# Technical Note

**Project:** Rudloe Drive, Quedgeley

**Subject:** Drainage strategy

<b>Client:</b>	Linden Homes	<b>Version:</b>	0.0
<b>Project No:</b>	06396	<b>Author:</b>	[REDACTED]
<b>Date:</b>	15/07/2022	<b>Approved:</b>	Daniel McCrudden

## **Appendix D      PJA Drainage strategy**

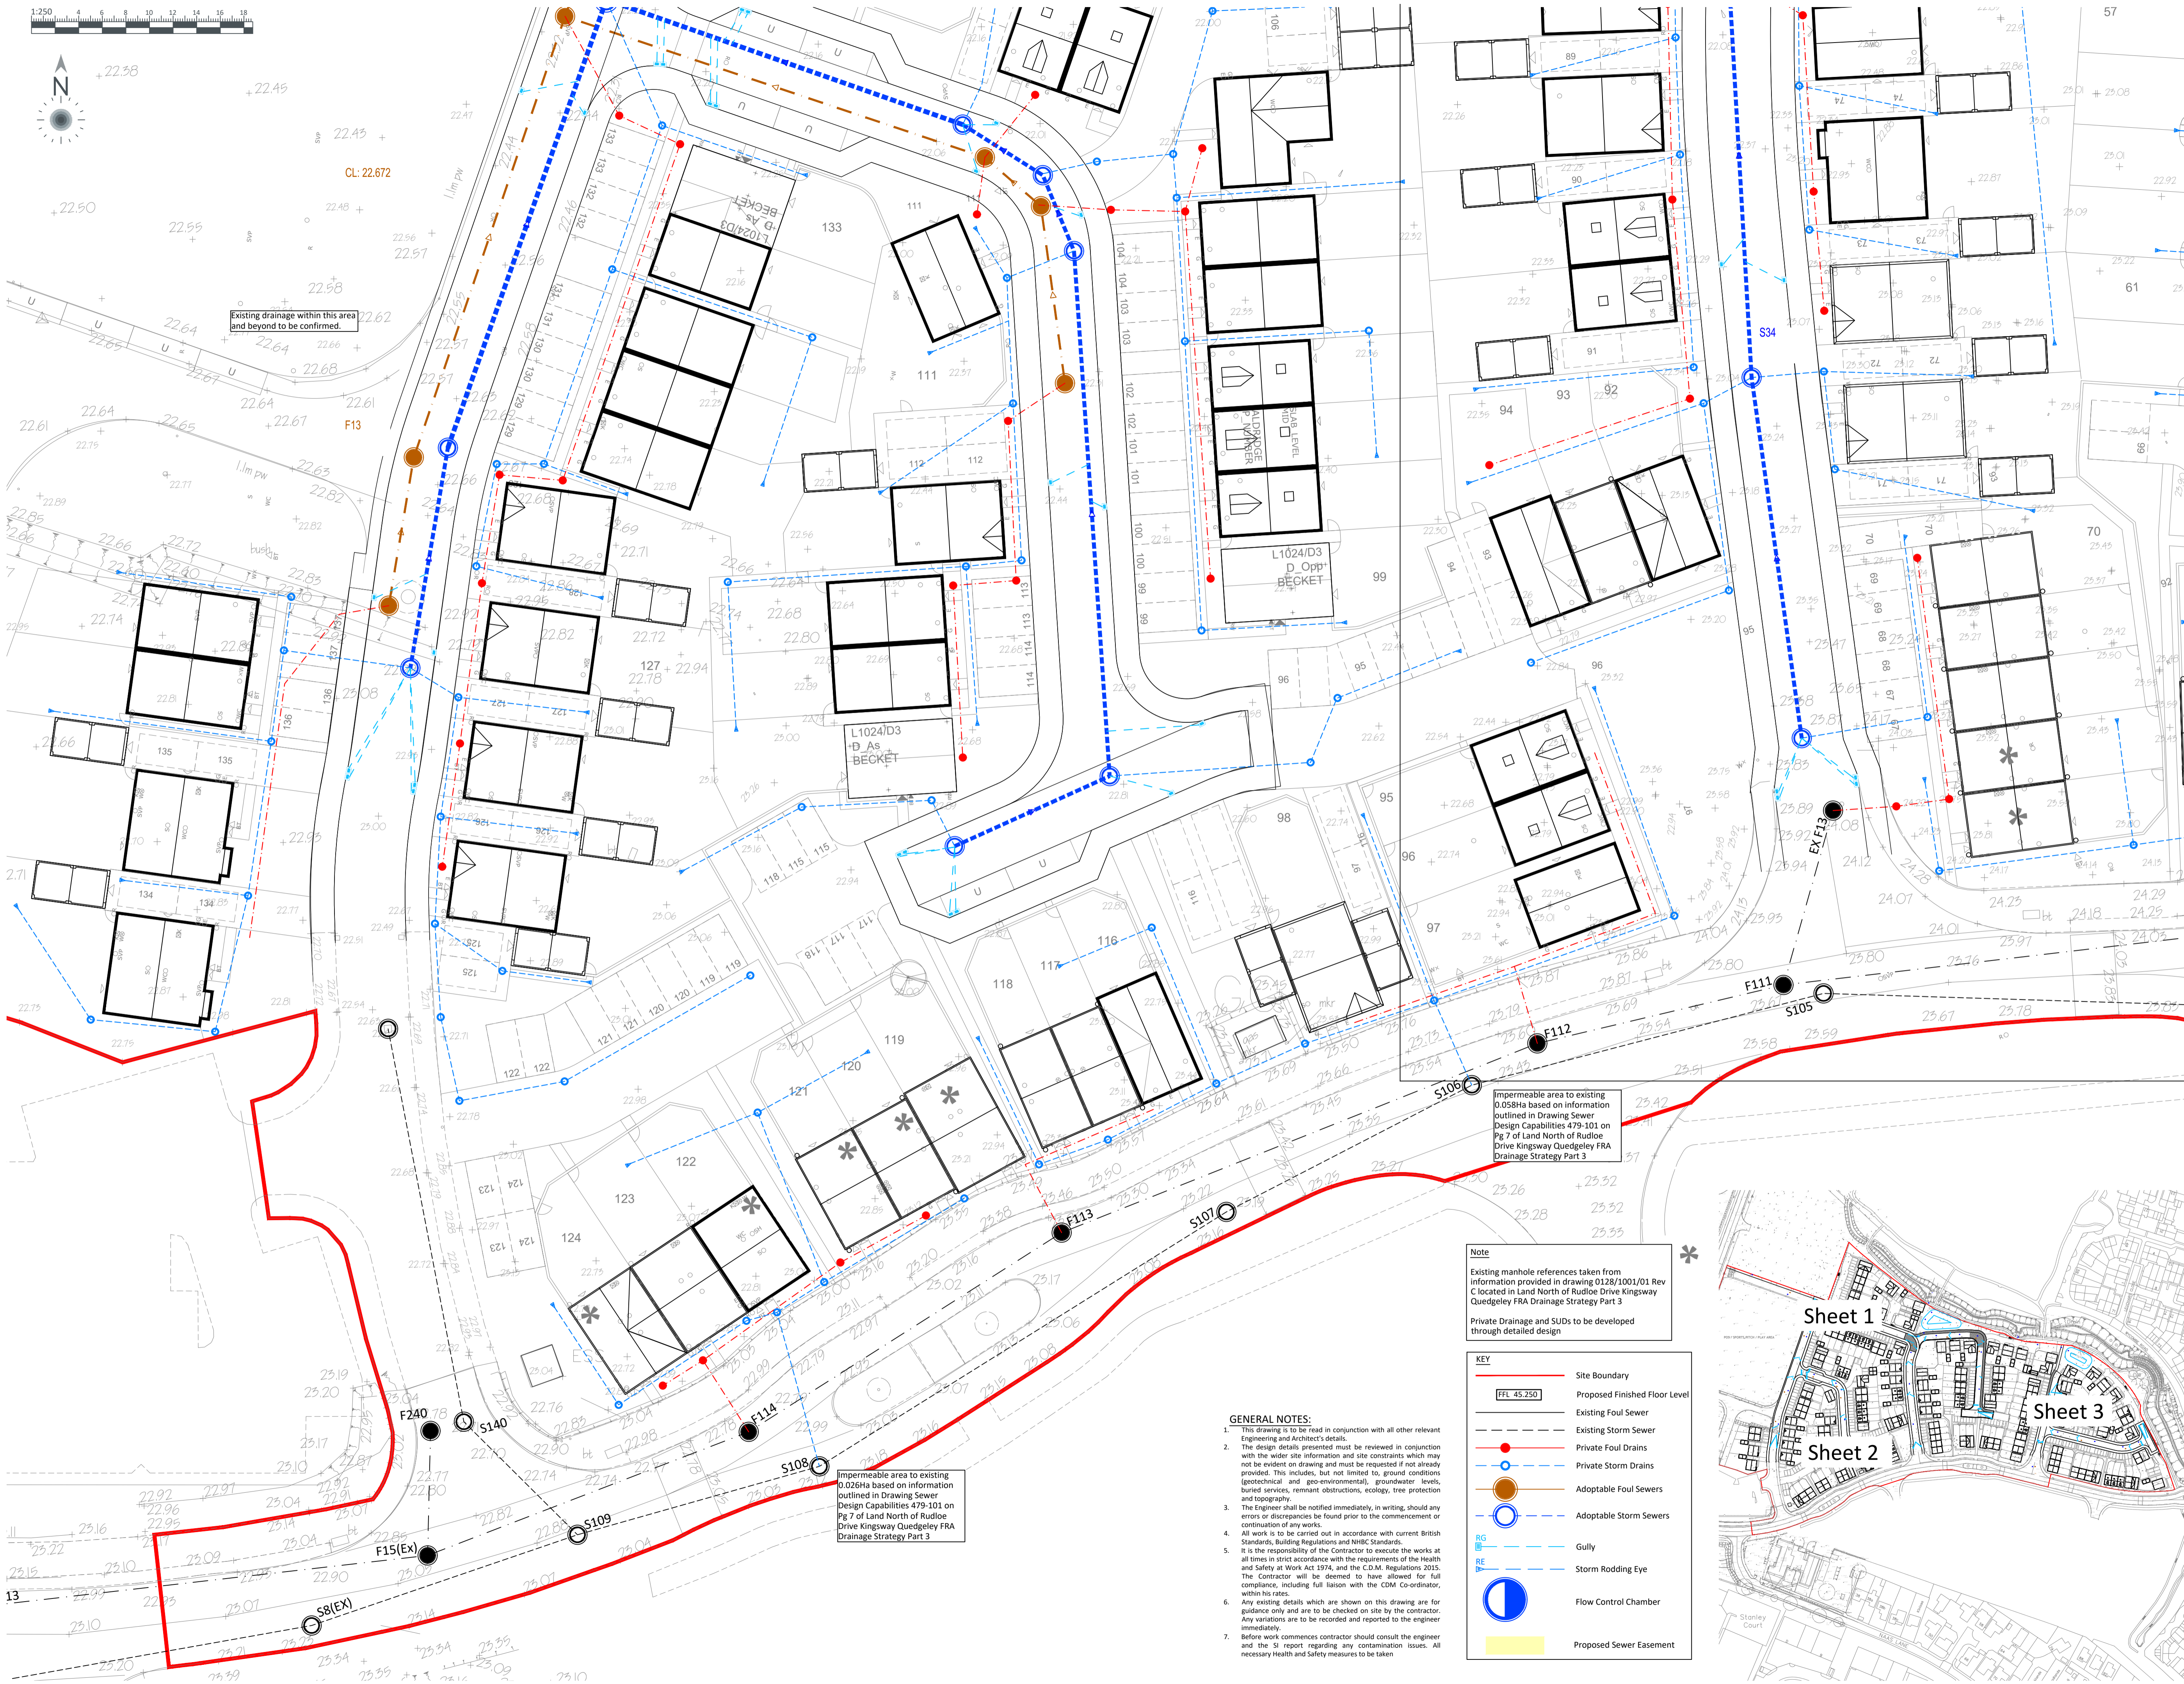
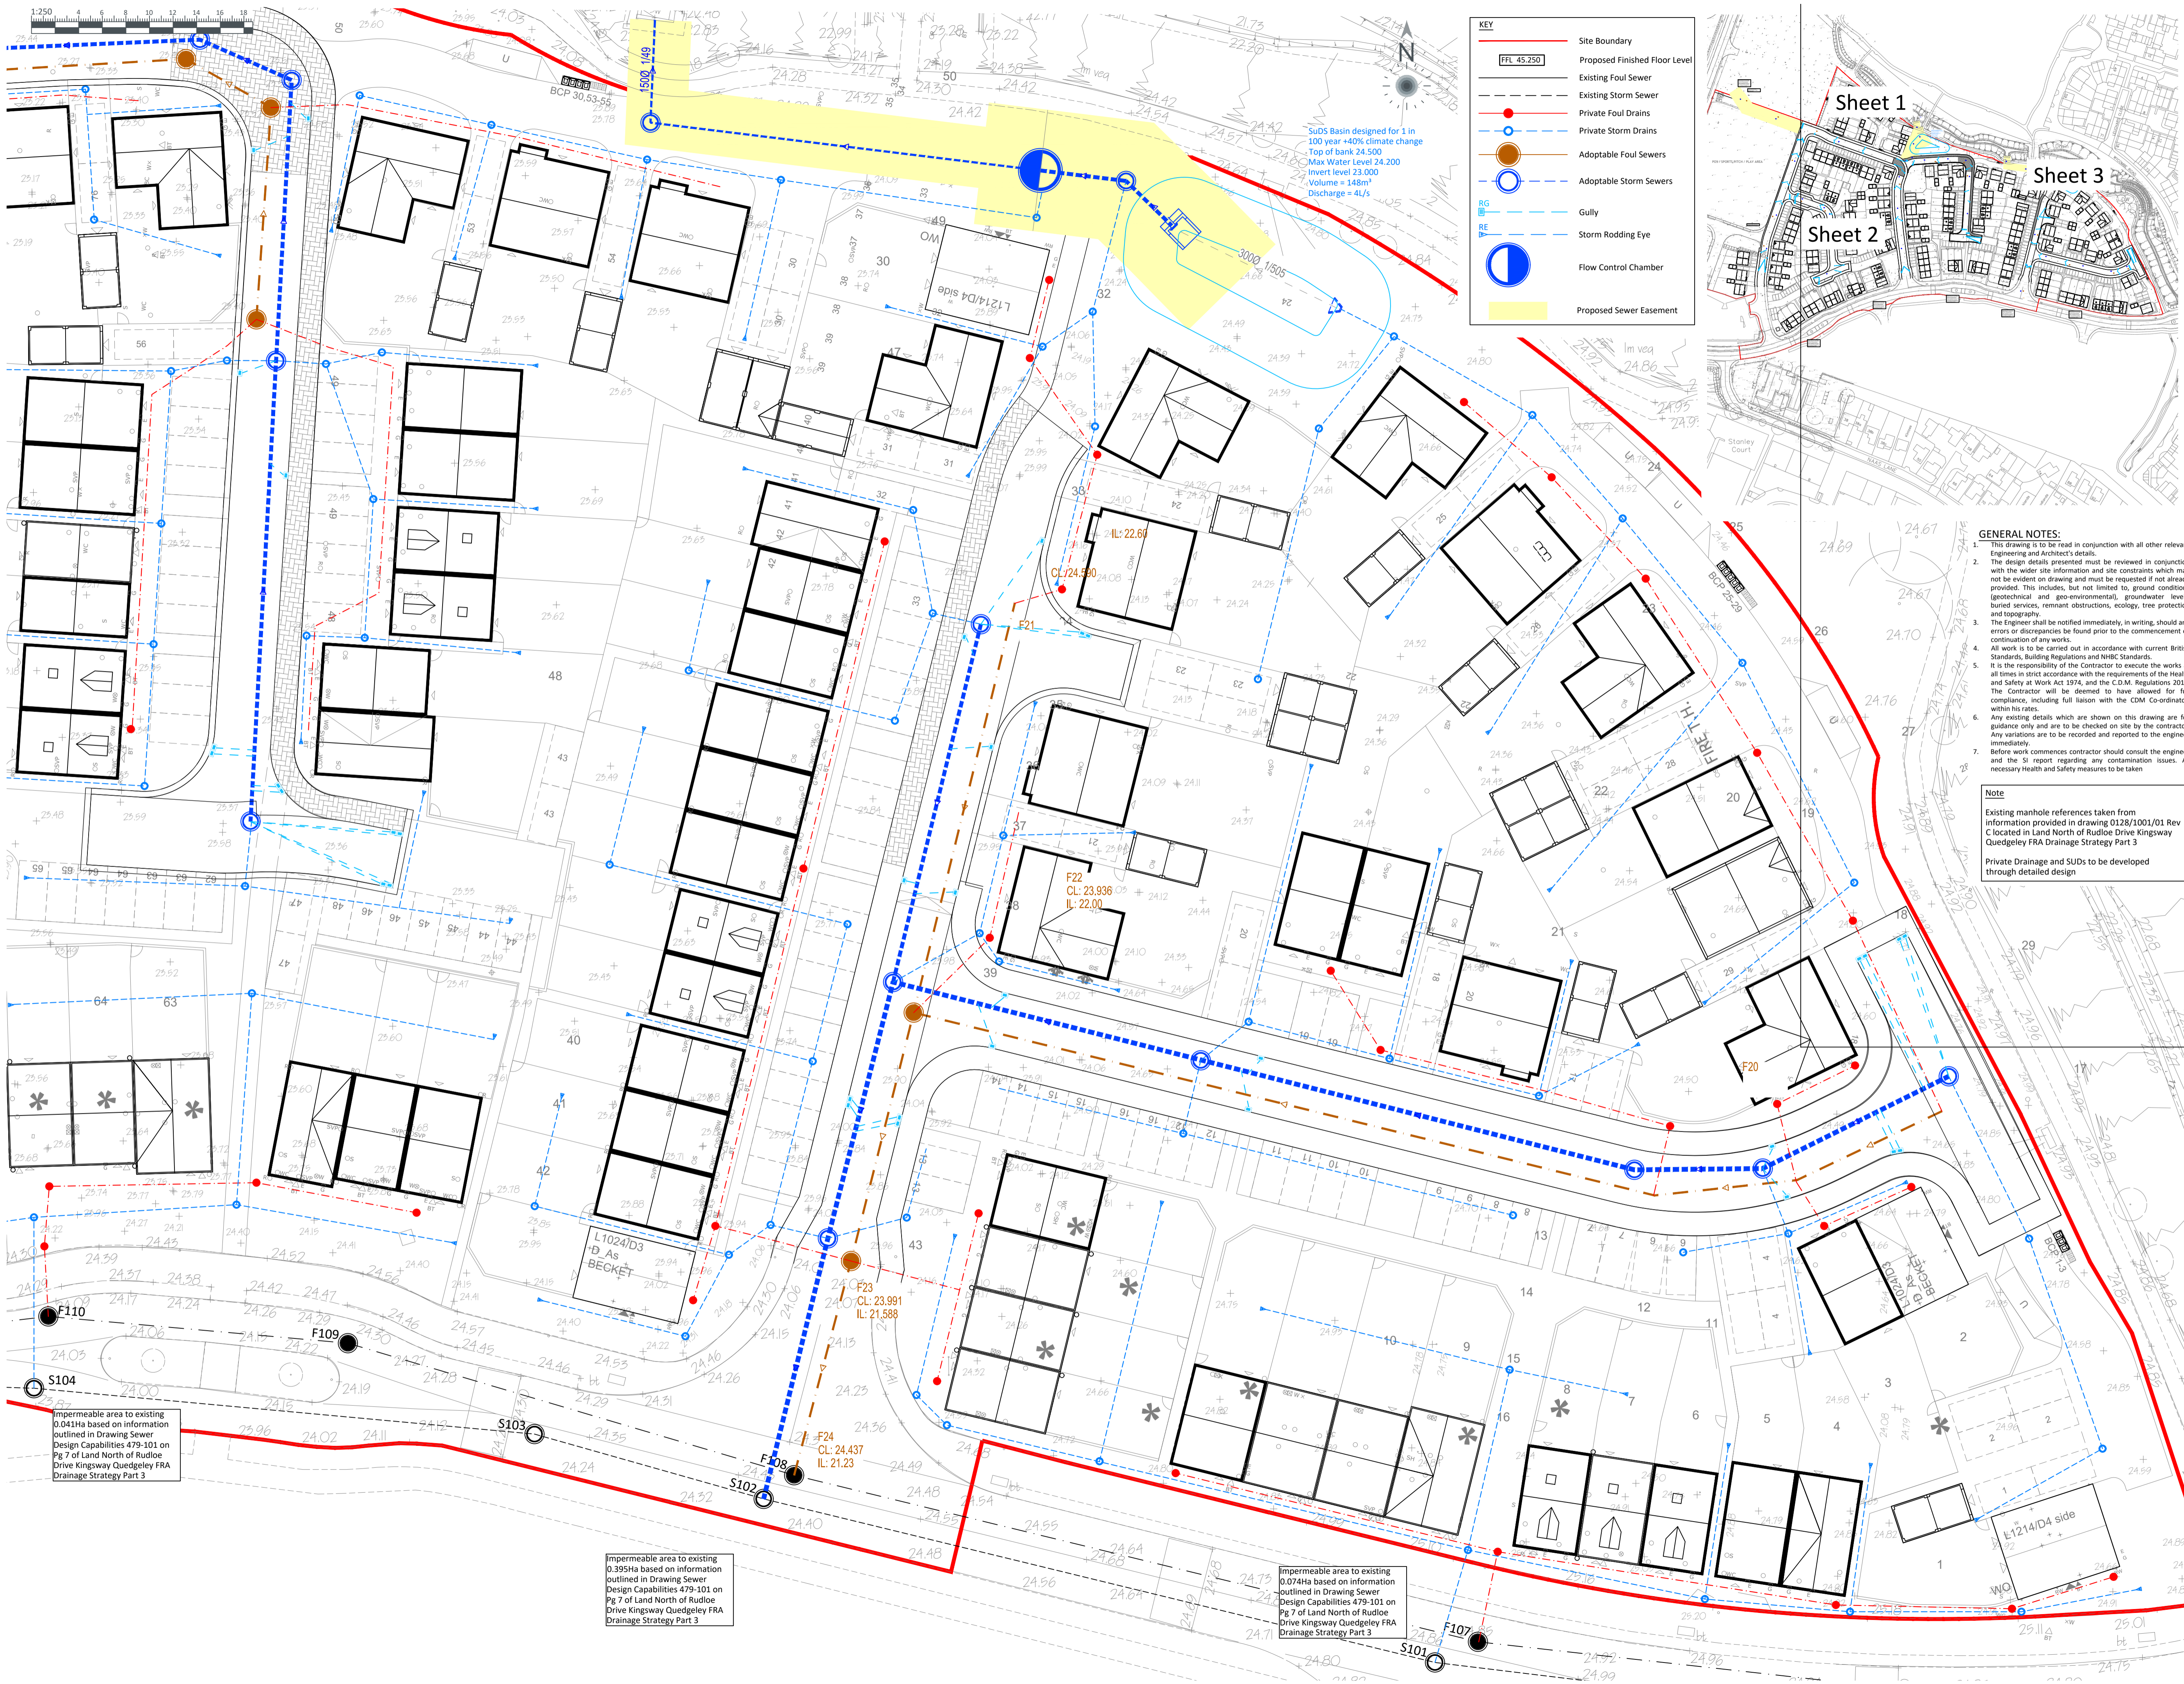
The LLFA objection, as quoted below, refers to the attenuation capacities of the two basins on site and how they are smaller than the volumes quoted on drawings previously submitted during the outline planning application stage.

*“This application refers to the reserved matters for planning consent 21/00490/OUT. That application showed the site developed in a way that required two attenuation basins with a total capacity for a volume of 432m<sup>3</sup> such that surface water could be discharged to the adjacent watercourse at 24 l/s. The plan submitted for this application only provides*

*attenuation storage capacity of 347m<sup>3</sup> to discharge surface water to the adjacent watercourse at 24 l/s. It is not clear where the layout offers any ability to reduce the attenuation storage capacity by 22%.”.*

The proposed drainage strategy submitted for reserved matters planning submission was shown on PJA drawings 0103-P0 through 0105-P0. These have subsequently been updated for detail

design and therefore, the latest PJA drawings 0210-P1 through 0212-P1 will be referred to throughout and are included within this document in Appendix D.

The proposals, like the outline strategy, utilise the three outfall locations specified in the site wide drainage strategy from the FRA. The drained impermeable areas used however, reflect the exact areas shown on the site layout plan. The catchment area split can be seen on PJA drawing 0405-P1, included within Appendix E.

The catchment split per outfall location is documented below in table 2. Within these updated proposals, an impermeable area of 1.607 ha is being drained through the existing sewers located in Newhaven Road and Rudloe Drive without restriction. Consequently, the combined impermeable area that is drained to the RAF tributary through the two attenuation basins is 0.811 ha.

Because a larger part of the catchment is routed through the western basin (0.580 ha) compared to the eastern basin (0.231 ha), the proposed strategy makes use of the acceptable discharge rate by apportioning 20 l/s to the western basin and 4 l/s to the eastern basin. To that end, a total storage capacity of 347m<sup>3</sup> is provided.

The total storage capacity of the two attenuation basins has therefore reduced from the outline planning strategy to that submitted for reserved matters. This is because more of the site is being routed to the existing outfalls in Newhaven Road and Rudloe Drive compared to the RAF tributary. The percentage of the site's catchment out-falling to existing sewers is now 66%, with the other 34% out-falling towards the RAF tributary.

This represents an 8% reduction in the overall site catchment split out-falling through the two attenuation basins into the RAF tributary (42% at outline compared with 34% at reserved matters). This, combined with the differing approach to the apportionment of the accepted discharge rate, results in the total storage capacity of the two basins reducing from one proposal to another.
